Public Works Department

November 27, 2017

RE: COMMENT LETTER – SANTA ANA REGION REVISED COMPLIANCE SCHEDULE FOR SHEL TMDL FOR NEWPORT BAY AND OTHER WATER QUALITY STANDARDS BASIN PLAN AMENDMENTS

Figure 1: Hole Lake Creek (natural, unlined section below Arlington Ave.)

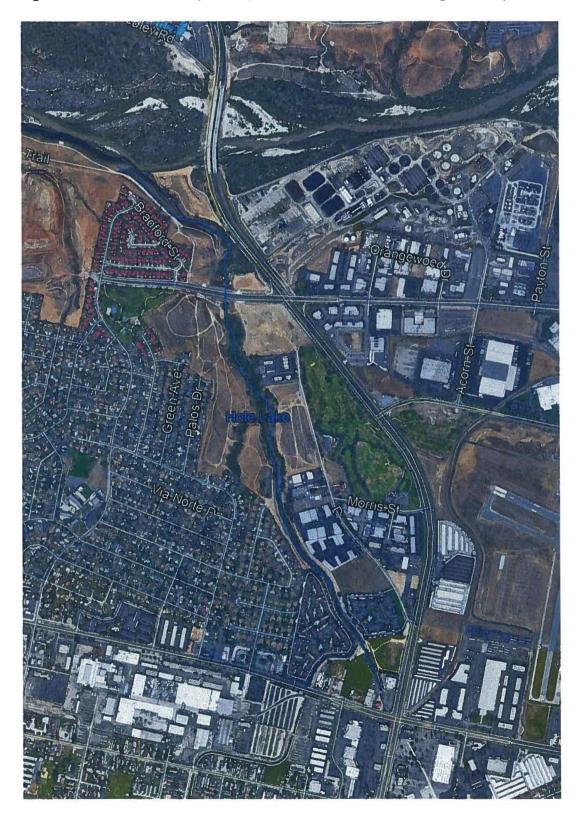
The staff report states that: "Hole Lake Creek contains pools of perennial water and wellestablished riparian areas."³ This is an accurate description of Hole Lake Creek from Arlington Avenue to the confluence with Reach 3 of the Santa Ana River. Above Arlington Avenue the culvert is a concrete-lined flood control channel with no "well-established riparian area" (see Fig. 1 in this comment letter). Figure 12 in the staff report fails to accurately depict this critical distinction made in the text of the same staff report. Therefore, we understood the Regional Board's approved action for Hole Lake Creek to apply only to the natural stream channel extending from Arlington Avenue to the Santa Ana River.

In order to avoid any possible confusion we recommend that a footnote be added to Table 3-1 describing Hole Lake Creek as the natural unlined channel extending from Arlington Avenue to the confluence with Reach 3 of the Santa Ana River. This would be a non-substantive change that is entirely consistent with the plain text of the accompanying staff report. It is also consistent with long-standing state and federal policy that draws a sharp distinction between a man-made MS4 conveyance and a water of the U.S.⁷ It is essential that this footnote be added to the Basin Plan itself in order to resolve the unintended inconsistency created by Figure 12 in the staff report. Alternatively, the SWRCB can revise its own adoption resolution to make this same point in a legally-binding manner.
